1 Final
2 RCRA Facility Investigation
3 Phase 2 Work Plan
4 Parcel 23
5 Revision 1.0
6

7 Fort Wingate Depot Activity
8 McKinley County, New Mexico
9

**RE: APPROVAL WITH MODIFICATIONS
FINAL RCRA FACILITY INVESTIGATION PHASE 2 WORK PLAN
PARCEL 23 REVISION 1.0
FORT WINGATE DEPOT ACTIVITY
MCKINLEY COUNTY, NEW MEXICO
EPA ID# NM6213820974
HWB-FWDA-18-004**

FIGURE 3-1
Previous Sample Locations
with Analytes Exceeding
2019 NMED SSLs

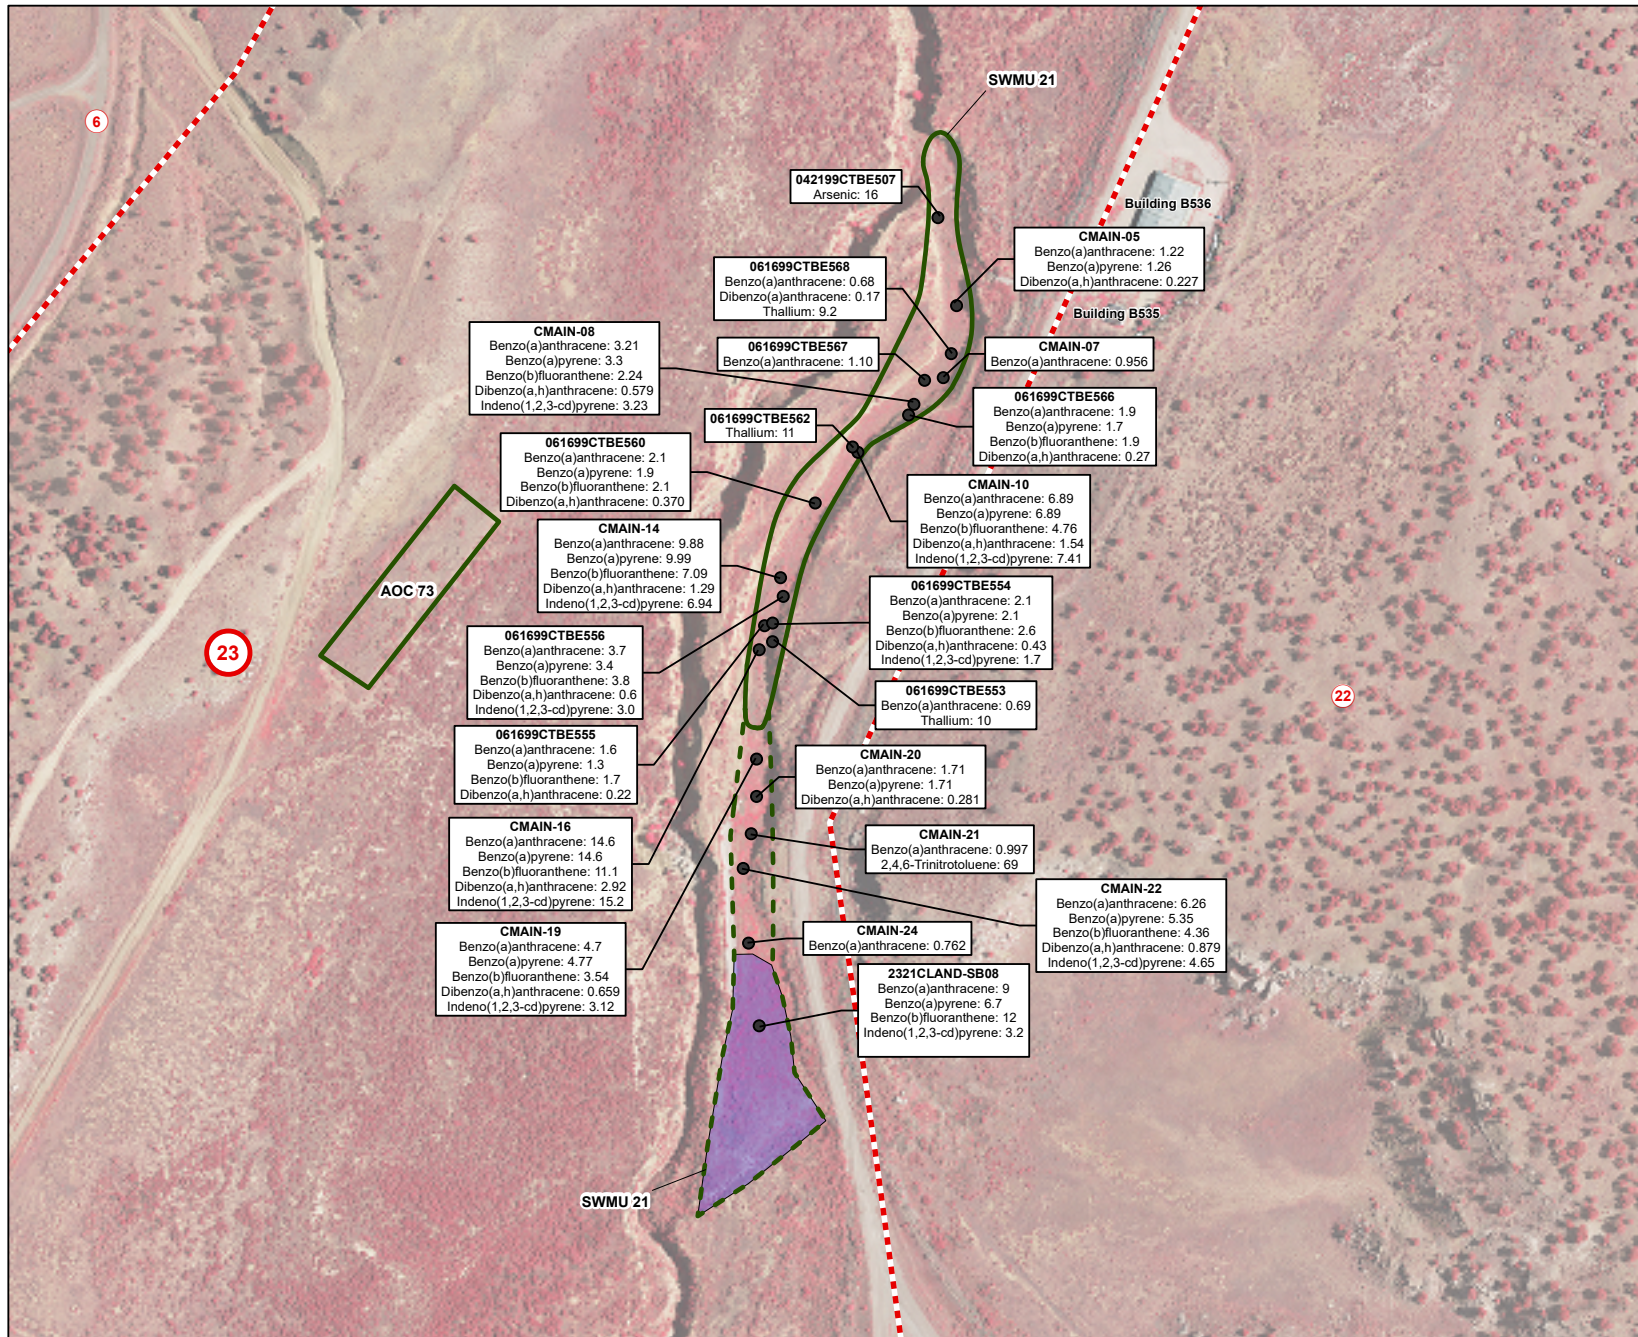
NMED Comment: Although the Permittee acknowledges that SWMU 21 is contiguous, the figures showing the SWMU boundaries (e.g., Figure 3-1) presents two separate boundaries. Revise all relevant figures and provide replacement figures.

NMED Comment: Although the Permittee acknowledges that SWMU 21 is contiguous, the figures showing the SWMU boundaries (e.g., Figure 3-1) presents two separate boundaries. Revise all relevant figures and provide replacement figures.

NMED Comment: The contaminant distribution shown in Figure 3-1, Previous Sample Locations with Analytes Exceeding 2017 NMED SSLs, suggests that the source area of potential groundwater contamination easily exceeds 0.5 acre. Since the DAF of 20 is protective of groundwater for a 0.5-acre source but not for a larger source area, the DAF values must be revised if groundwater is found to be affected. Discuss whether a DAF of 20 is appropriate for the site in the revised Work Plan.

NMED Comment: In Figure 3-1, a distribution of SVOC exceedances was observed in the area between the two boundaries as well as in the areas within the boundaries. Therefore, these two areas must be considered to be contiguous and must not be evaluated separately. In addition, the lateral extent of SVOC exceedances is not defined to the north and south along the arroyo. The extent of contamination has not been defined. The beef ingestion pathway must be evaluated in the Phase 2 Investigation Report. Revise the Work Plan accordingly.

Permittee Response: Concur. Figures 1-3, 3-1, 3-2, and 4-1 have been revised to show the proposed SWMU 21 boundary revision.
